SUBJECT: WATERFORD STEAM ELECTRIC STATION, UNIT 3 – SUMMARY OF
CONFERENCE CALL REGARDING THE SPRING 2014 STEAM GENERATOR
TUBE INSPECTIONS (TAC NO. MF3888)

**CONFERENCE CALL SUMMARY REGARDING SPRING 2014
STEAM GENERATOR TUBE INSPECTION ACTIVITIES**

STEAM GENERATOR TUBE INSPECTION DISCUSSION DURING WATERFORD 3's 2014 (1R19) OUTAGE

Waterford 3 Primary to Secondary Leakrate based on Tritium for Cycle 19

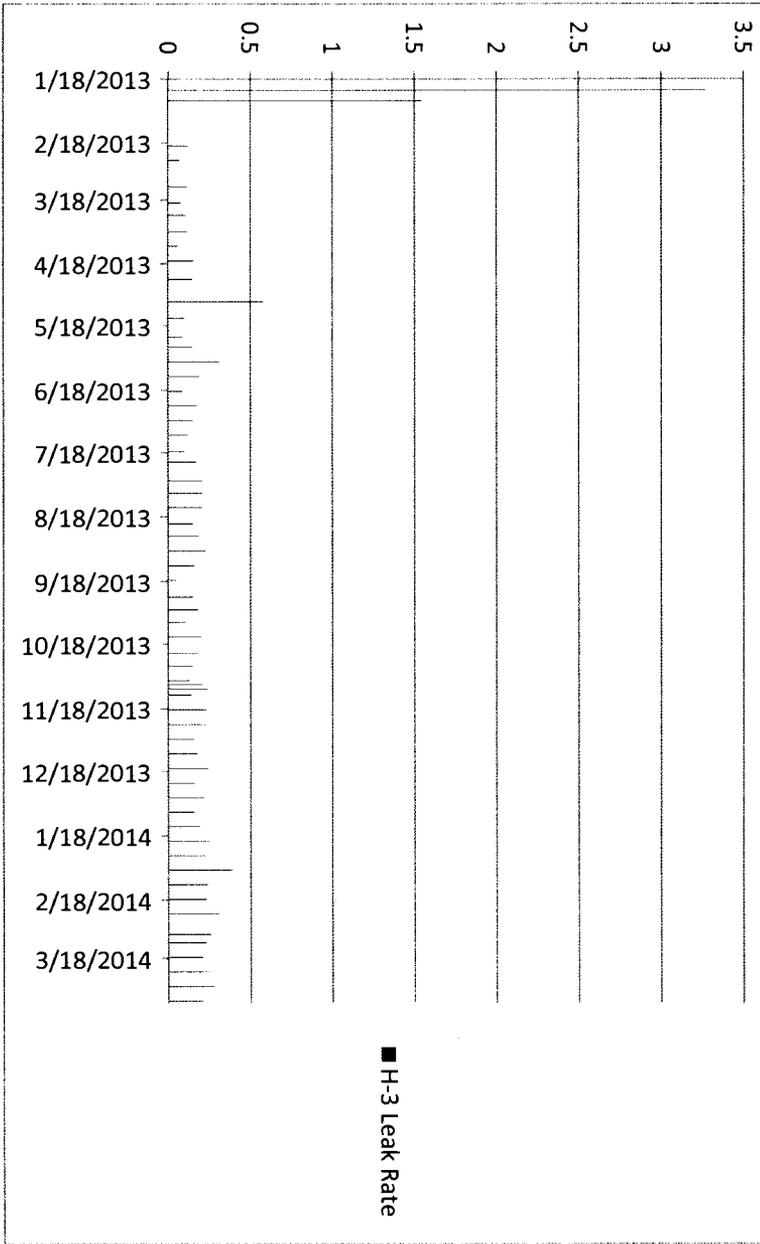
- This is the first SG inspection following installation of replacement SGs in the fall of 2012.
- In the Primary to Secondary Leakrate graph on page 6 of Enclosure 2, the y-axis units are gallons per day (gpd). Because there was no detectable gamma radiation associated with the tritium leak rate, the licensee concluded there was no primary-to-secondary leakage.
